STATE OF DELAWARE
DEPARTMENT OF TRANSPORTATION
800 BAY ROAD
P.O. BOX 778
DOVER, DELAWARE 19903

February 17, 2009

DeIDOT Contract Number: 95-090-01; Federal Aid Project Number: IM-N056(27)
I-95 Delaware Turnpike Improvements Project
I-95/SR 1 Interchange/I-95 Turnpike Mainline
Turnpike Mainline from SR 1 to SR 141; I-95/SR 1 Interchange; I-95 Northbound
Widening Extension
New Castle County, Delaware
Environmental Reevaluation [*Change in interchange design*]

The current reevaluation details modifications in the design of the I-95/SR 1 interchange portion of the project. The design changes are being incorporated into the project to provide additional traffic operational and safety improvements within the interchange. An environmental evaluation of the currently proposed design has been completed, and the changes would increase the impacts to wetlands by an additional 0.26 acres. Mitigation for this additional impact will be accommodated within the Cathcart wetland mitigation site (identified as Site 7 in the

January 2009

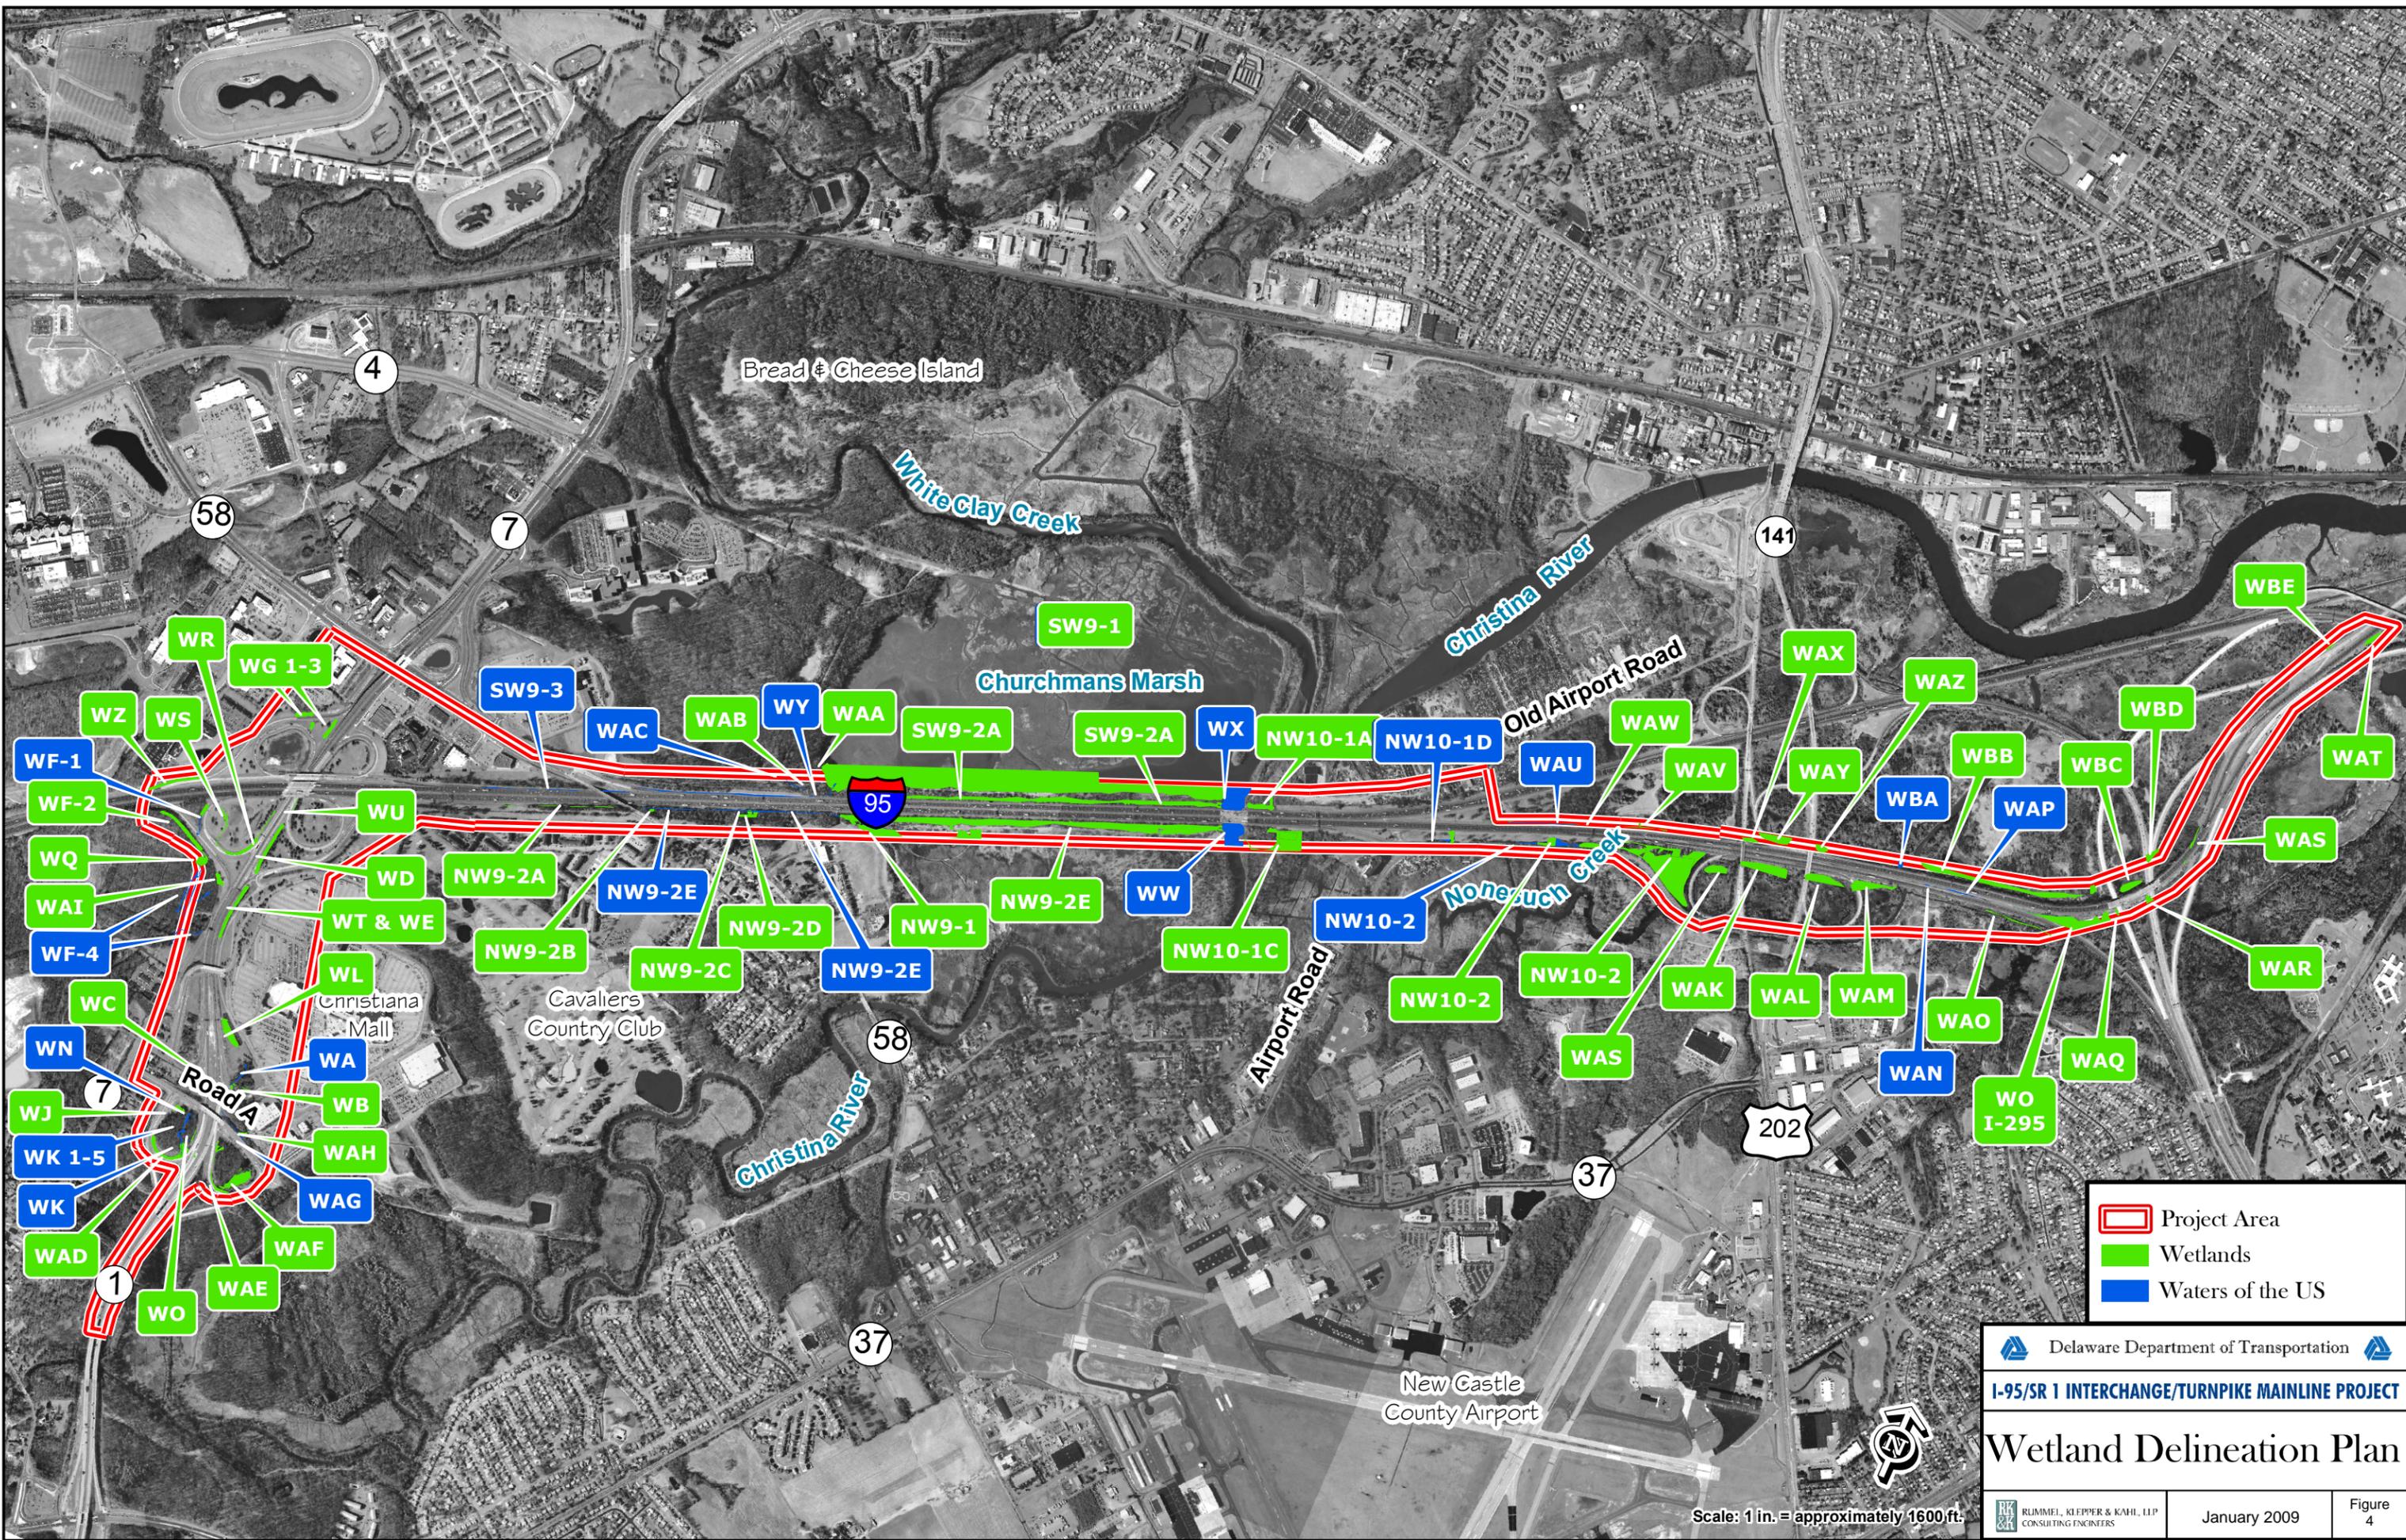
- The existing southeast quadrant loop ramp (from I-95 northbound to SR 7 northbound) has been eliminated and replaced by a semi-directional flyover ramp (identified on **Figure 3** as Ramp C) that extends from the southwest outer ramp from northbound I-95, passes over SR 7 and merges with northbound SR 7.

- The existing northbound lanes of I-95, north of the interchange, are shifted approximately 40 feet to the outside to accommodate Ramp B, which will fly over northbound I-95 and extend as the median lane of I-95.
- Ramp B (SR 1 northbound to I-95 northbound) will split in the vicinity of the southwest quadrant. The left lane will fly over northbound I-95, and become the median lane of the northbound I-95 mainline, as noted above. The right lane of Ramp B (Ramp B1) will extend along the outside of existing northbound I-95 and remain barrier-separated from the northbound I-95 mainline until north of the Churchmans Road bridge, where the lane merges with the existing outside mainline lane.
- The ramp (Ramp R1) to/from the Christiana Mall Road will be relocated approximately 150 feet south of its present location.

- The relocation of the Ramp R1 bridge approximately 150 feet to the south will allow for a lower profile for the ramp bridge and the reconstructed Christiana Mall Road, thus reducing the impact to the mall parking lot and eliminating a proposed retaining wall. Shoulder reductions in some areas have been reduced from 16/24 feet to 12 feet to accommodate the changes and avoid additional property acquisition from the Mall.

Wetland Delineation Plan

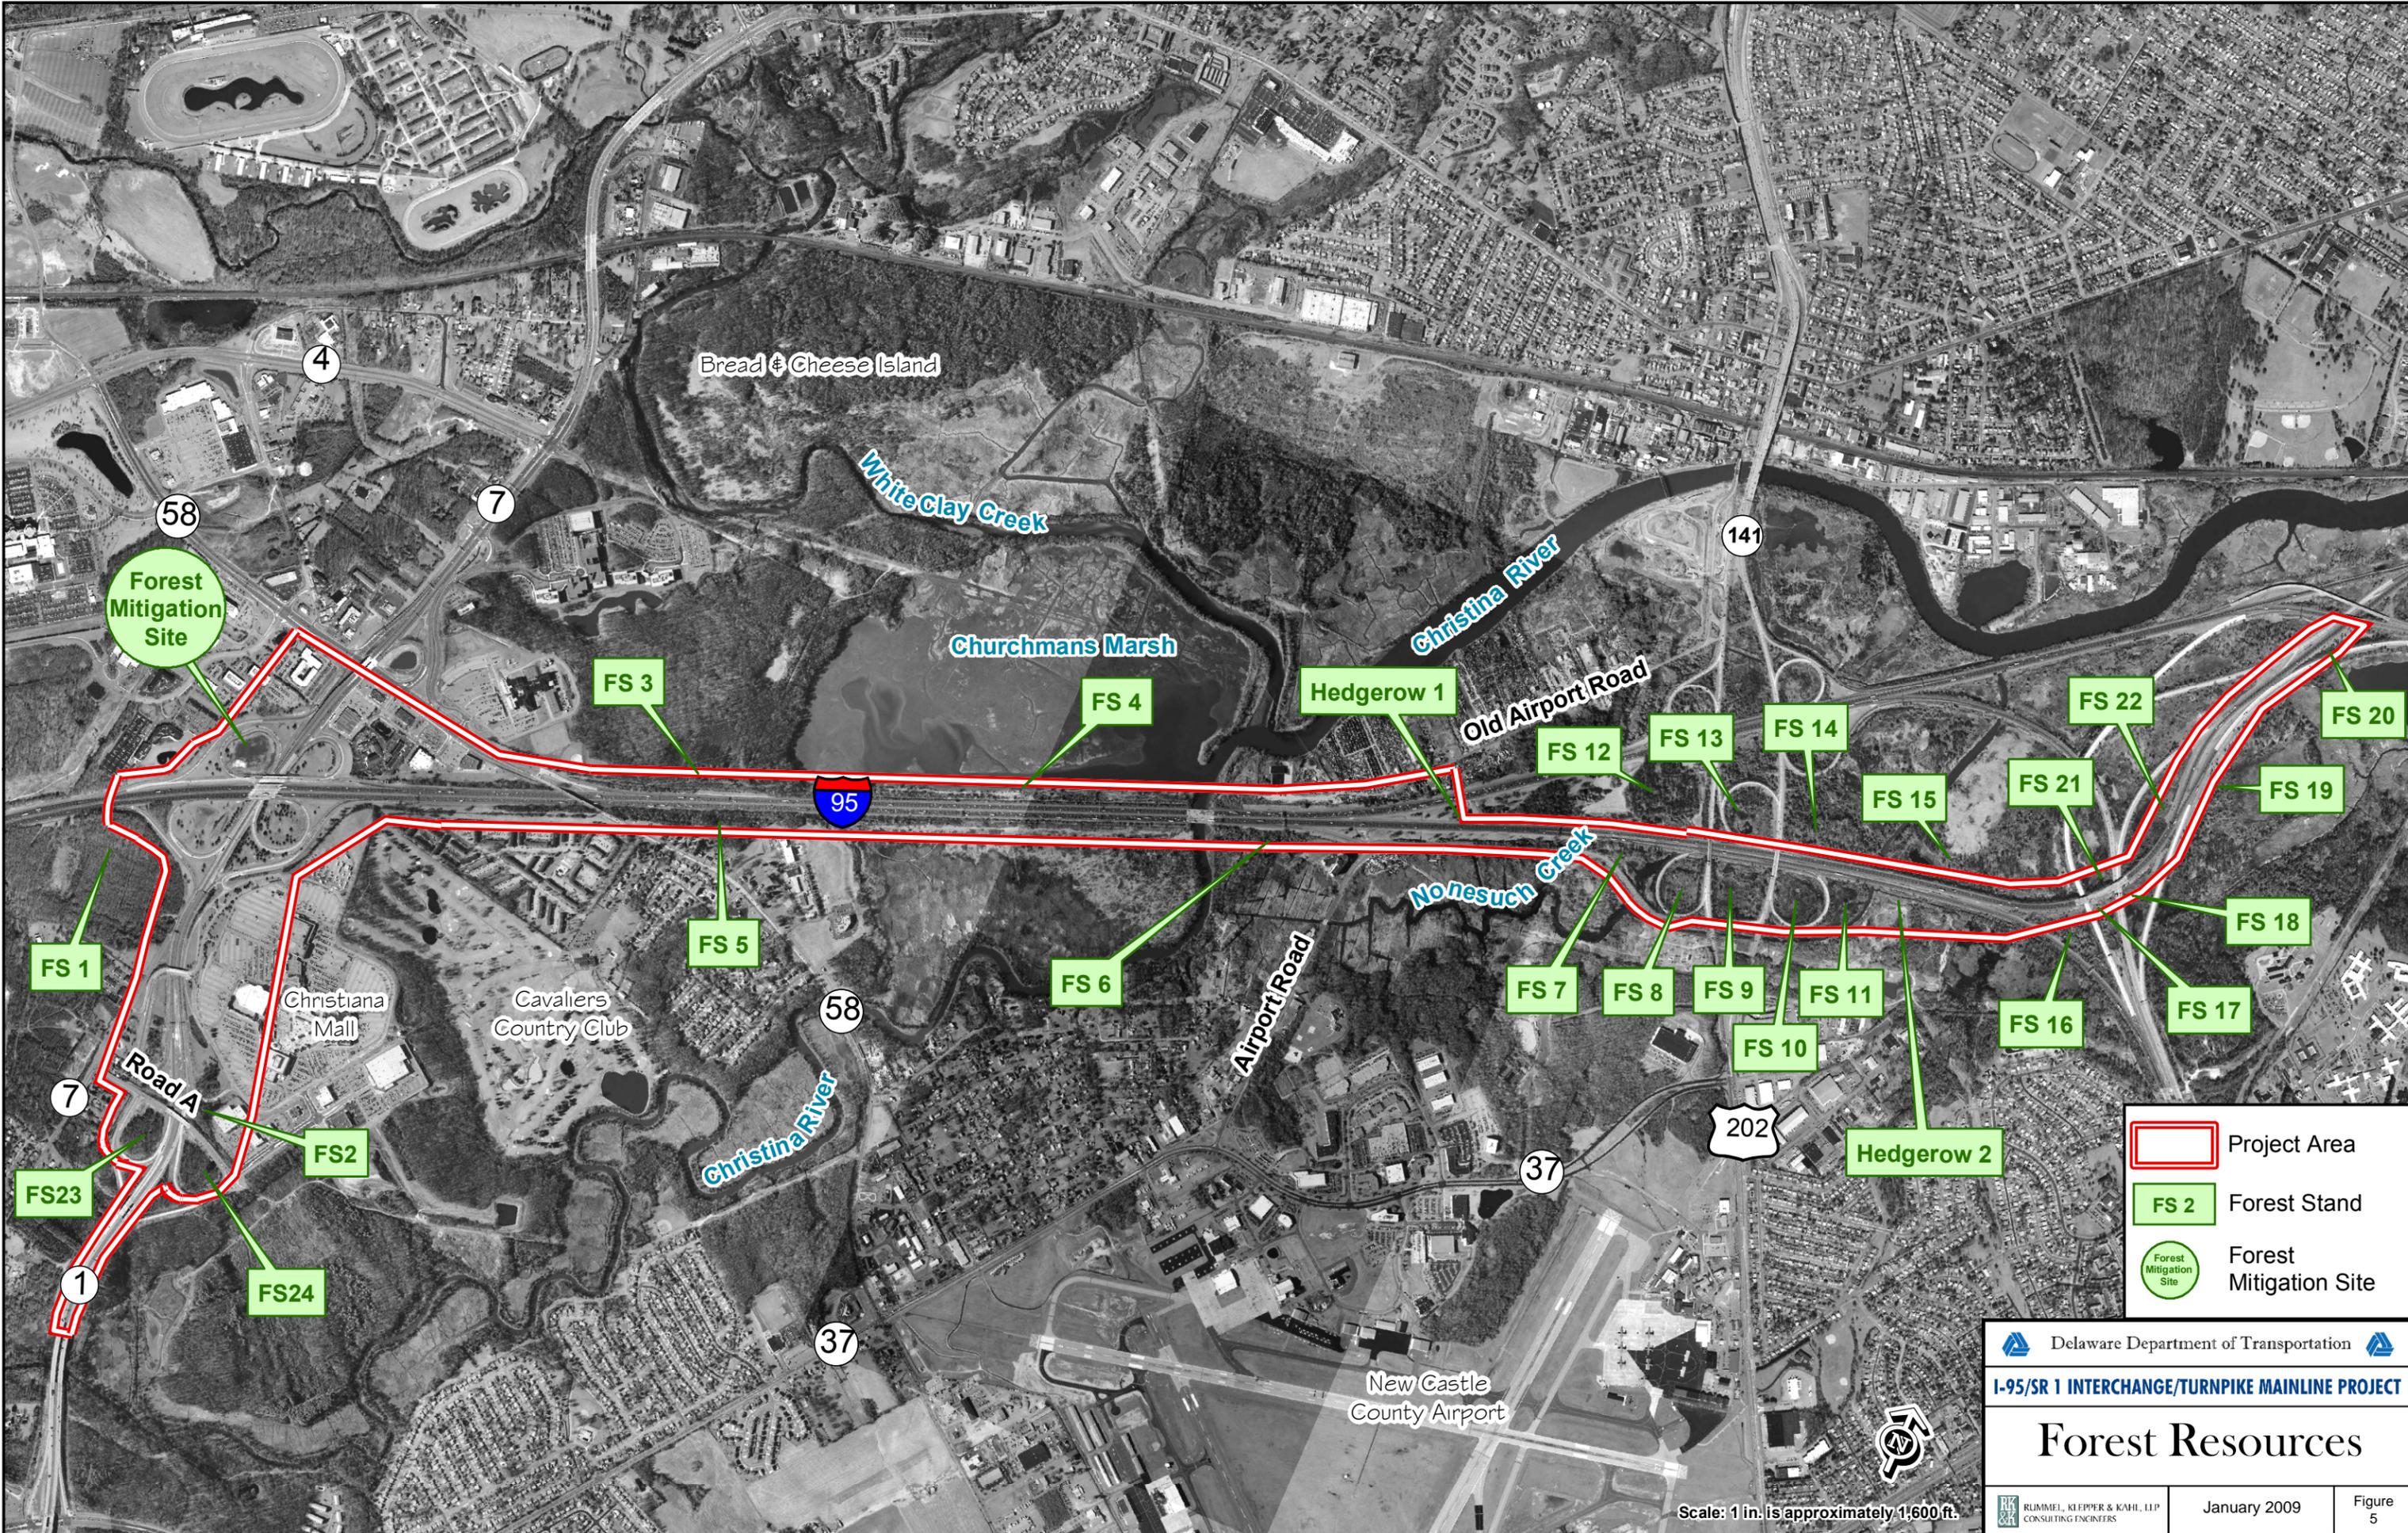
There are no newly-identified streams or wetlands within the interchange project area. **Figure 4** shows the approximate locations of all Waters of the US, including wetlands, identified in the I-95/SR 1 interchange project area. Following the 2006 reevaluation, where the revised/extended design of the Turnpike mainline *reduced* the number of acres of impacts from 2.17 acres to 2.02 acres, the FHWA received an ACOE permit to impact a total of 2.08 acres of wetlands and other Waters of the US. There will be an additional 0.26-acre increase in impacts to Waters of the US due to the modifications of ramps and bridges in the current design. **Table 3** highlights the total impacts to Waters of the US, while **Table 4** details the changes due to the current design.

The modifications to Ramp B will result in an increase of 0.10 acre of non-tidal wetland impacts (wetlands WD, NW9-2B, NW9-2C and NW9-2D as shown on *Figure 4*). The change in design from the loop ramp in the southeast quadrant to a semi-directional flyover ramp will result in no change to wetland impacts. The relocation of the Ramp R1 bridge approximately 150 feet to the south will result in an increase of 0.16 acres of impacts to non-tidal wetlands (wetland WL on *Figure 4*). The current design would change the total impacts to wetlands and other Waters of the US from the January 2006 impact of 2.02 acres to 2.28 acres. Wetlands would account for 1.02 acres, and waters (streams, channels and ditches) would account for the remaining 1.31 acres.

Forest Resources

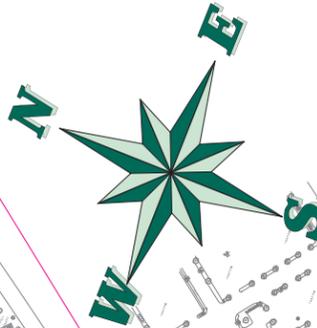
There will be an additional 0.35 acres of forest impact due to the design modification. Forest Stand FS 5 (shown on **Figure 5**) will be impacted by Ramp B1 as it merges with I-95 along the outside of the southbound roadway. This will increase the total forest impacts to 4.35 acres. An area of reforestation is available following the removal of the loop ramp in the southwestern quadrant (southbound SR 7 to southbound I-95) that will accommodate a total of 4.97 acres of new forest, after some soil modification. An additional 0.40 acres is still available on the Cathcart mitigation site.
